8XC51RX

SPECIFICATION UPDATE

Release Date: July, 1996

Order Number: 272885-001

Figure 1. Internal and External Data Memory Address Space with EXTRAM = 0

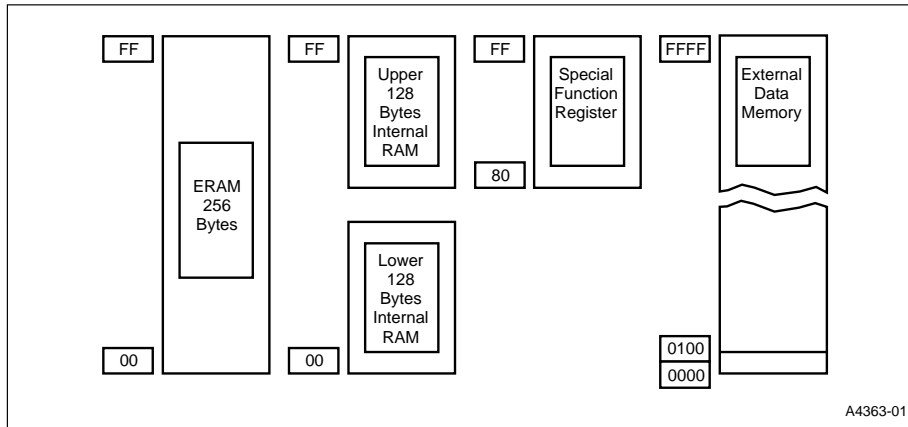
003. Upgrading Considerations

PROBLEM: The default value of EXTRAM bit is 0. To use external memory, customers will need to set the EXTRAM bit to 1.

Figure 1 contains the internal and external memory address space with EXTRAM = 0. This condition accesses the 256 bytes of extended RAM and disables external memory access.
